Access Compliance Report

Public Rights-of-Way

Intersection ID: 10662	Main Street: E_36TH_ST	Cross Street: HOLT_ST	Location: E
ADA ID: 1CF6C2517D5A	Ramp Type: PerpDiag	Initial Pass/Fail: Fail	Overall Compliance: No
		Severity Score: 8.75

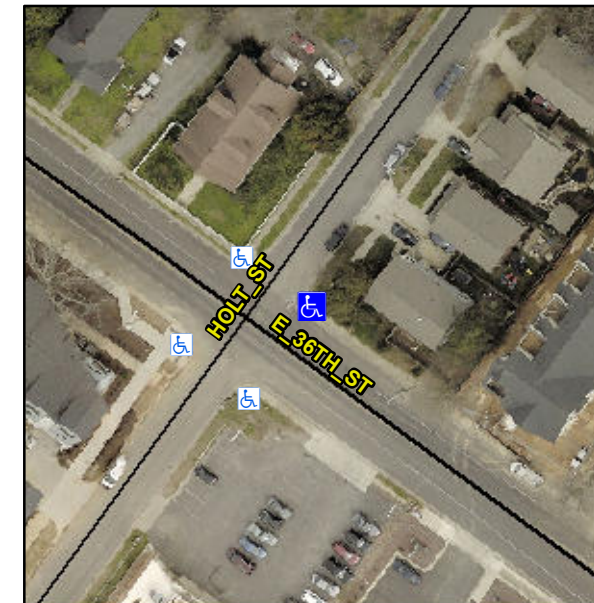
Not Found, R304.5.1

Compliance	Description	Data	Compliance	Description	Data
N/A	Ramp Length (in)	42.0	Yes	Ramp Slope (%)	7.1
No	Ramp Width (in)	47.5	Yes	Ramp XSlope (%)	0.6
N/A	Flare Type LT	N/A	N/A	Flare Type RT	N/A
N/A	Flare Slope LT (%)	N/A	N/A	Flare Slope RT (%)	N/A
N/A	Flare Traversable LT?	N/A	N/A	Flare Traversable RT?	N/A
N/A	Landing Length (in)	N/A	N/A	DWS Provided?	N/A
N/A	Landing Width (in)	N/A	N/A	DWS Contrast?	N/A
N/A	Landing Slope (%)	N/A	N/A	DWS Length (in)	N/A
N/A	Landing X Slope (%)	N/A	N/A	DWS Full Width?	N/A
N/A	Landing Curb? (Y/N)	N/A	N/A	DWS Offset (in)	N/A
N/A	Shared Landing?	N/A			
N/A	Gutter Ponding?	N/A	N/A	Gutter Slope (%)	N/A
N/A	Gutter Lip Ht (in)	N/A	N/A	Gutter X Slope (%)	N/A
N/A	Painted X Walk1?	No	N/A	Painted X Walk2?	No
	X Walk 1 Direction	To NW		X Walk 2 Direction	To SW
N/A	X Walk 1 Width (in)	N/A	N/A	X Walk 2 Width (in)	N/A
	X Walk 1 Slope (%)	1.6		X Walk 2 Slope (%)	1.6
	X Walk 1 X Slope (%)	0.9		X Walk 2 X Slope (%)	1.2

Remove & Replace Curb Ramp With Two New Directional Ramps or Equivalent.
